# **SECTION 96(1a) APPLICATION**

Premises: Lot 1 in DP 514220, No. 12 Toronto Avenue,

Amendments: Amend Plans – Timber Screen

**Development Application: 2014/0612**

**View of Timber Screen**

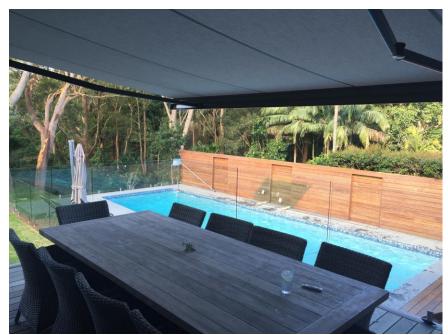
Construct timber screen along the Eastern Elevation of existing pool in lieu of approved glass pool fence.
